UNITED STATES PATENT AND TRADEMARK OFFICE

APPLICATION NO.	FILING DATE	FIRST NAMED INVENTOR	ATTORNEY DOCKET NO.	CONFIRMATION NO.
10/728,022	12/03/2003	Gopal K. Chopra	03-389 (US01)	8331
41696	7590	12/04/2006	EXAMINER	
VISTA IP LAW GROUP LLP 12930 Saratoga Avenue Suite D-2 Saratoga, CA 95070			SOLANKI, PARIKHA	
			ART UNIT	PAPER NUMBER
			3737

Office Action Summary

[Source: Buchholtz et al (US Patent No. 5,409,006)]

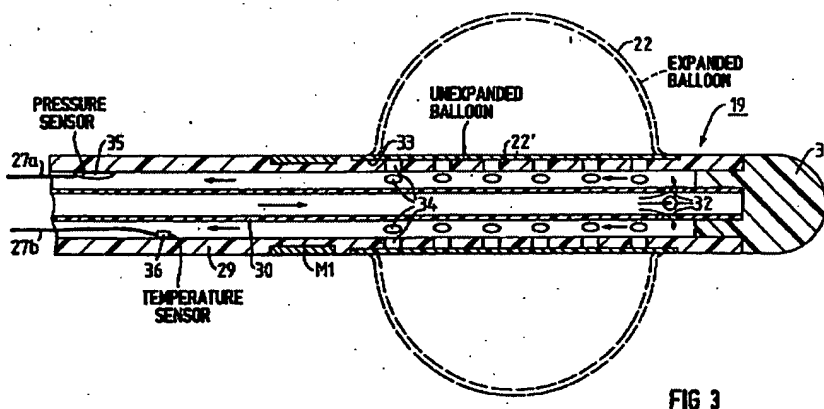
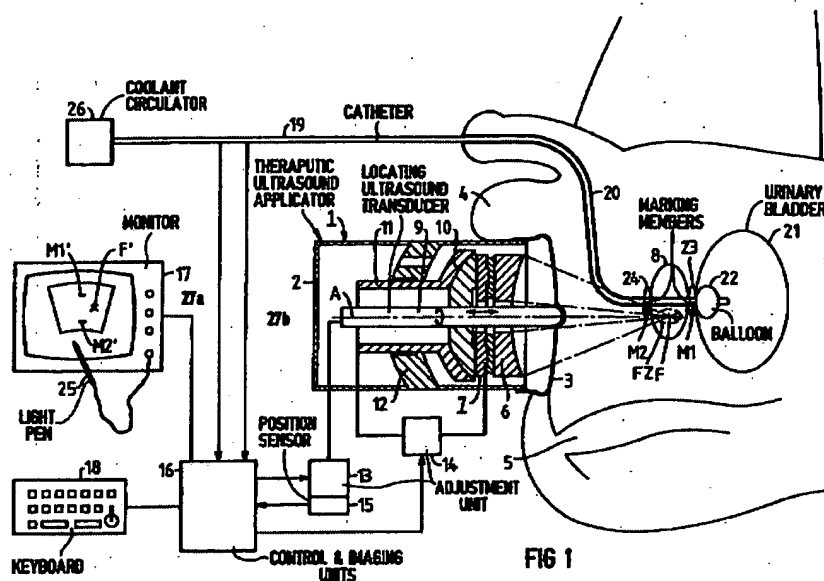
8. Claims 1-4, 7, 9-13, 21, 23 and 24 are rejected under 35 U.S.C. 102(b) as being anticipated by Buchholtz (US Patent No. 5,409,006). Buchholtz ('006) discloses a method and apparatus for delivering acoustic energy to a target site (Abstract).

The apparatus of Buchholtz ('006) includes a catheter having a distal end, a proximal end, a lumen extending there between, a channel located adjacent to the transducer, a fluid source in fluid communication with the channel, and an acoustic energy sensor secured to the

catheter distal end (col. 1 lines 56-61, col. 3 lines 27-43, col. 3 lines 61-68, col. 7 line 56 – col. 8 line 4, Figs. 1 & 3). While Buchholtz ('006) provides the embodiment for the treatment of benign prostate hyperplasia, Buchholtz ('006) states that the apparatus and method may be used to treat other maladies, and as such the acoustic energy sensor provided by Buchholtz ('006) is considered the same as a neurological signal sensor (col. 8 lines 30-32).
